## **WILKINSON-KINGSWAY SUBDIVISION**

APPLICATION NUMBER 1 DATE September 4, 2014

REQUEST Subdivision

# DETAIL SITE PLAN

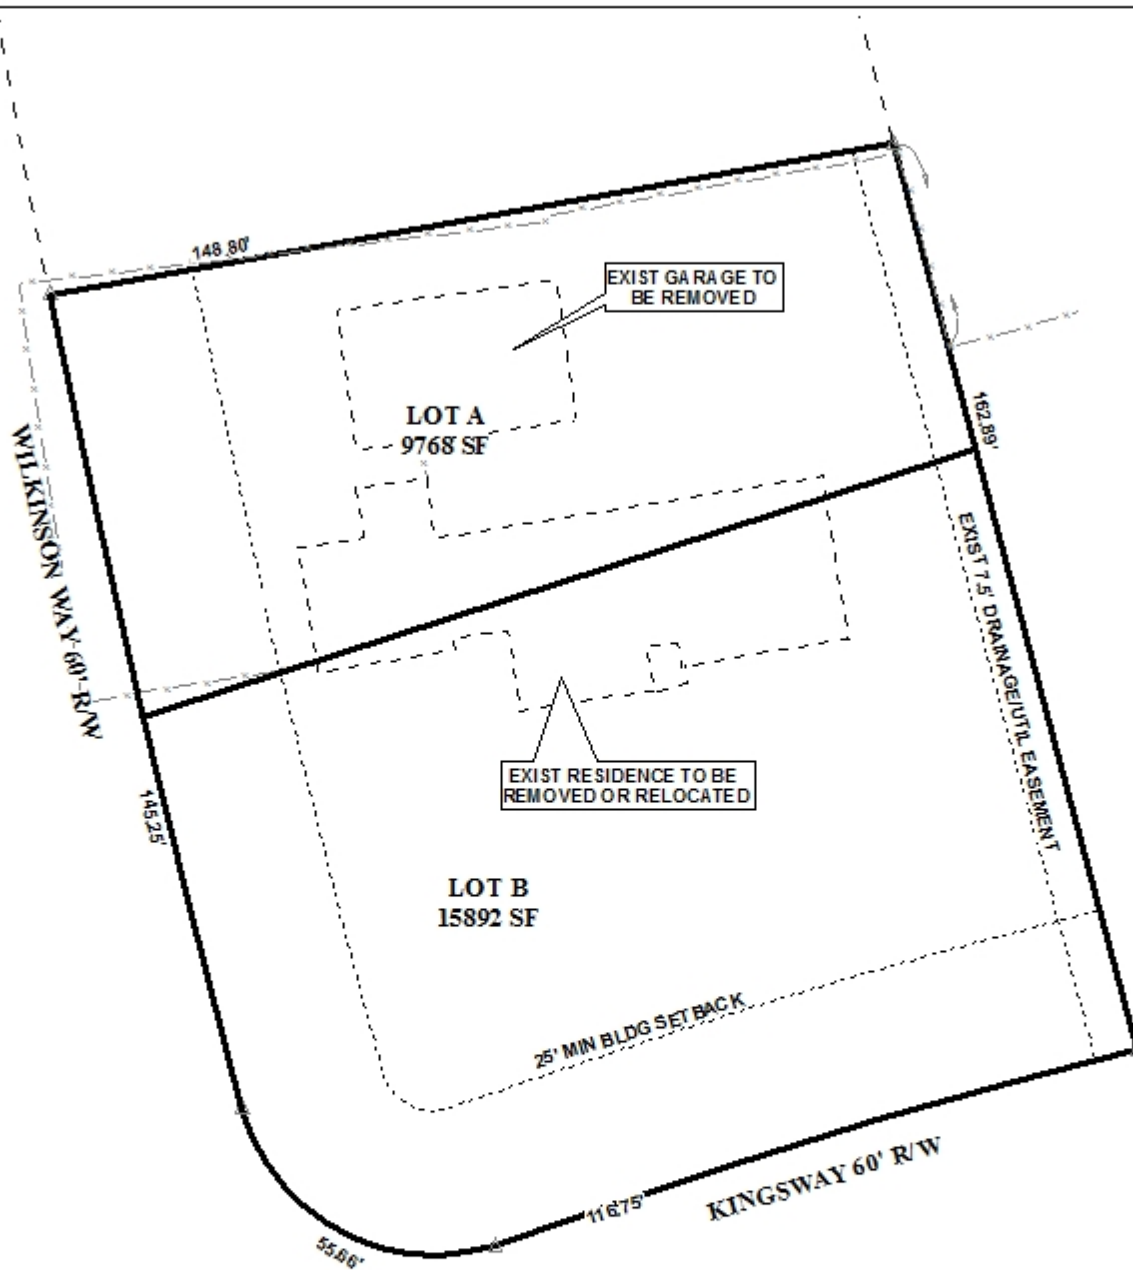
The site fronts onto Kingsway and Wilkinson Way, both minor streets with curb and gutter, and are both illustrated as having compliant right-of-ways of 60-feet; therefore no dedication should be required. If approved, a note should be placed on the Final Plat limiting each lot to one curb cut, with the size, design, and location of the curb cut to be approved by Traffic Engineering and conform to AASHTO standards.

The preliminary plat illustrates the 25' minimum building setback line, as required in Section V.D.9. If approved, the minimum building setback line should be retained on the Final Plat.

There is a 7.5' drainage/utility easement illustrated along the Eastern property line for the subject site. If approved, a note should be placed on the Final Plat, that no structures are to be placed in the easement.

It should be noted that an existing dwelling and freestanding garage are illustrated on the site, with the proposed new interior lot line running through the middle of the dwelling. The preliminary plat states that both of these structures are to be either removed or relocated. Permits to remove these structures from the property should be obtained prior to the signing of the Final Plat.

- 1) obtain a permit for the removal of the dwelling and garage from the site prior to the signing of the Final Plat;
- 2) retention of the 25' minimum building setback line;

- 3) retention of the lot sizes in square feet and acres on the plat;
- 4) placement of a note stating that each lot is limited to one curb cut each with the size, location and design of all curb cuts to be approved by Traffic Engineering and conform to AASHTO standards;

- 5) placement of a note on the Final Plat stating that no structures are to be placed in any easement;
- 6) compliance with Engineering comments (*The following comments should be addressed prior to submitting the FINAL PLAT for acceptance and signature by the City Engineer: Provide all of the required information on the SUBDIVISION PLAT (i.e. signature blocks, signatures, certification statements, written legal description, required notes, legend, scale, bearings and distances) that is required by the current Alabama State Board of Licensure for Professional Engineers and Land Surveyors. Add a note to the SUBDIVISION PLAT stating that a Land Disturbance permit will be required for any land disturbing activity in accordance with the of the Storm Water Management and Flood Control Ordinance (Mobile City Code, Chapter 17 , Ordinance #65-007 & #65-045), latest edition. Storm water detention may be required for any existing development (since 1984) that did not receive Land Disturbance permitting and for any future addition(s) and/or land disturbing activity. Add a note to the SUBDIVISION PLAT stating that as shown on the 1984 aerial photo (FLIGHT 22 - #81) the Lot will receive historical credit of impervious area towards storm water detention requirement per the Storm Water Management and Flood Control Ordinance (Mobile City Code, Chapter 17, Ordinance #65-007 & #65-045), latest edition. Coordinate with City Engineering Department staff to establish the exact amount prior to the submittal of the Land Disturbance Permit application. Add a note to the SUBDIVISION PLAT stating that each residential lot will be allowed to add the following impervious area to the lot before storm water detention is required to be provided: LOT A – 2,000 sf, LOT B – 2,000 sf. Add a note to the Plat stating that the approval of all applicable federal, state, and local agencies (including all storm water runoff, wetland and floodplain requirements) will be required prior to the issuance of a Land Disturbance permit. Provide and label the monument set or found at each subdivision corner. Add a signature block for the Owner, Notary Public, Planning Commission, Traffic Engineer, and City Engineer. Provide the Surveyor's Certificate and Signature. Provide the Owner's (notarized), Planning Commission, and Traffic Engineering signatures. Add a note that sidewalk is required to be constructed along the frontage of each lot, or parcel, at time of development, unless a sidewalk waiver is approved. Provide a copy of the Final Plat along with the original when submitting for City Engineer signature..*);
